**CULTURAL RESOURCES OFFICE  
PRESERVATION BOARD**  
**REGULAR MEETING – ZOOM MEETING**  
**MONDAY, December 5, 2022 — 4:00 P.M.**  
*www.stlouis-mo.gov/cultural-resources*

<b>PRELIMINARY REVIEWS:</b>	<b>JURISDICTION:</b>	<b>PROJECT:</b>	<b>PAGE:</b>
A. 2601 Market Street.....	Preservation Review Area.....	Demolish office building and construct two hotels	3

**FRONT ELEVATION OF ADDITION FACING MCNAIR**

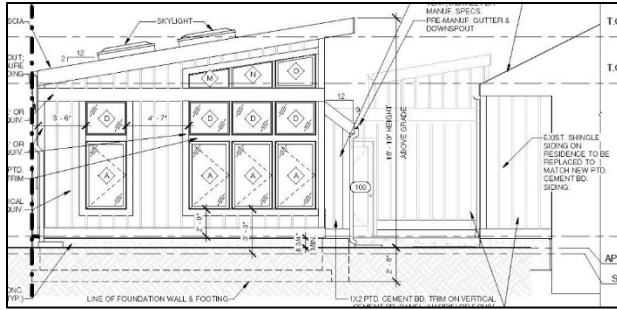
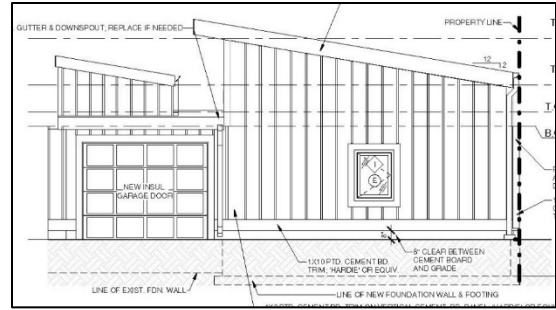
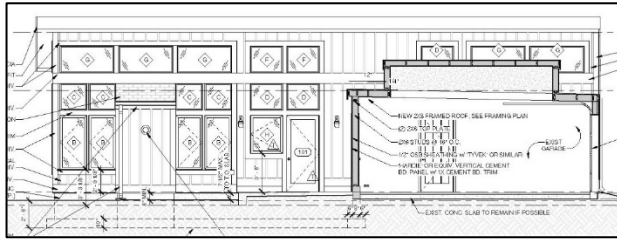
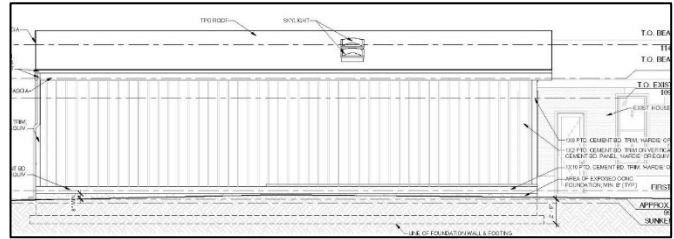
**The applicant has not presented a Model Example and the design proposed is entirely contemporary.**

**The proposed addition is contemporary in design and not considered compatible with historic district resources.**

**Does not comply. The building is a single story. Building on the block are all 2- or 2-1/2 stories with the exception of 2860 McNair itself, which is 1-1/2 stories.**

**Does not comply. The addition would be sheathed in vertically-scored cement board siding.**

**Does not comply. There is no indication that the foundation would be painted; however, only 8 inches of it would be exposed.**

That the Preservation Board withhold Preliminary Approval for the project as it does not comply with the Benton Park Historic District Standards.

**FRONT (WEST) ELEVATION**

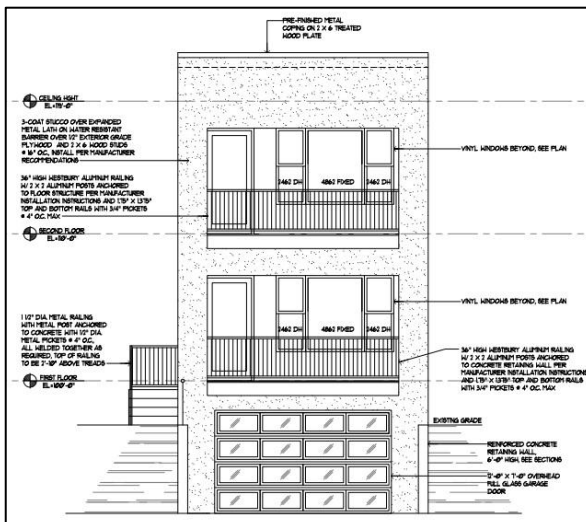
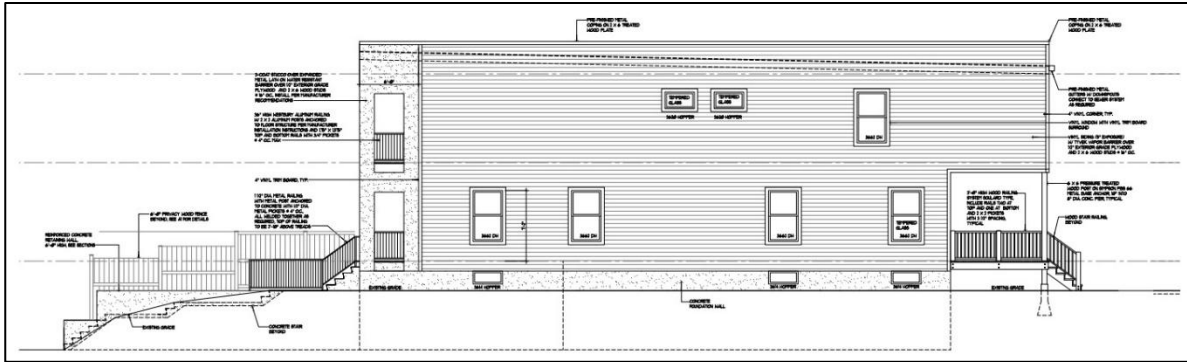
The project would not be architecturally compatible with the existing block face nor its overall character or exterior materials. The proposal would demolish existing houses at both 1224 Kraft and 1230 Kraft for the construction of two 3-story single-family buildings. As there is no rear alley to provide vehicular access, the proposed design would provide off-street parking via front-entry 2-car garages facing the street. The front yard of both houses would be excavated and wide driveways/parking areas created, entirely disrupting the steep terracing of the block. The intervening house at 1228 Kraft is not a part of this project and thus would be isolated and flanked by high retaining walls on each side property line.

Based on these preliminary findings, the Cultural Resources Office recommends that the Preservation Board uphold the Director's Denial of the application to demolish 1224 Kraft Street as it does not meet the criteria for demolition under the Preservation Review District ordinance.

FRONT (WEST) ELEVATION

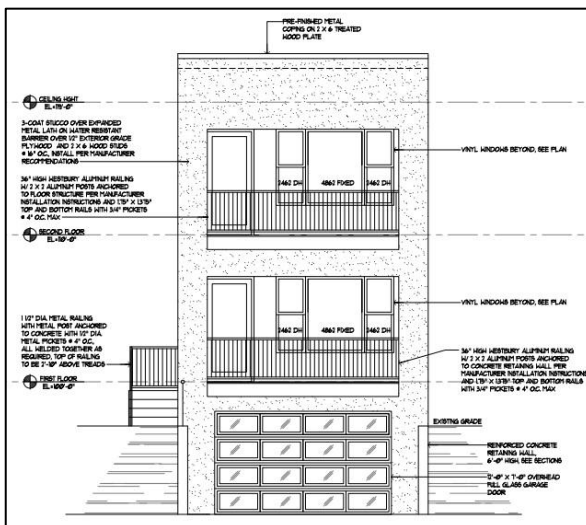
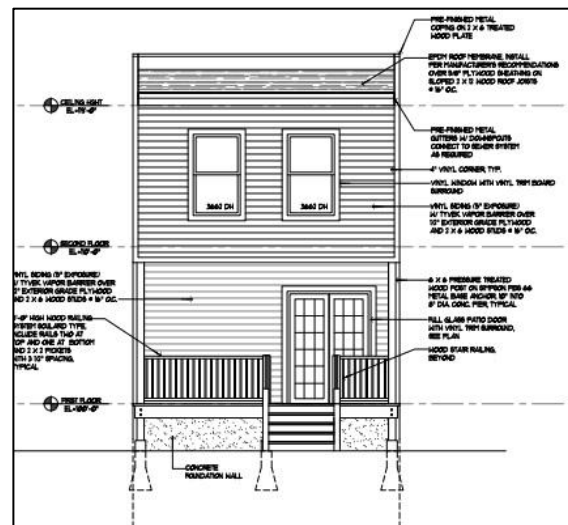
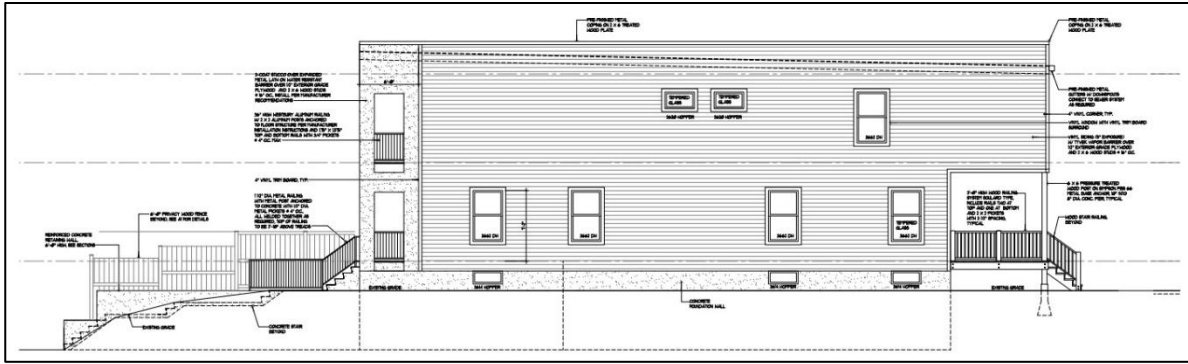
**The project would not be architecturally compatible with the existing block face nor its overall character or exterior materials. The proposal would demolish existing houses at both 1224 Kraft and 1230 Kraft for the construction of two 3-story single-family buildings. As there is no rear alley to provide vehicular access, the proposed design would provide off-street parking via front-entry 2-car garages facing the street. The front yard of both houses would be excavated and wide driveways/parking areas created, entirely disrupting the steep terracing of the block. The intervening house at 1228 Kraft is not a part of this project and thus would be isolated and flanked by high retaining walls on each side property line.**

Based on these preliminary findings, the Cultural Resources Office recommends that the Preservation Board uphold the Director's Denial of the application to demolish 1230 Kraft Street as it does not meet the criteria for demolition under the Preservation Review District ordinance.
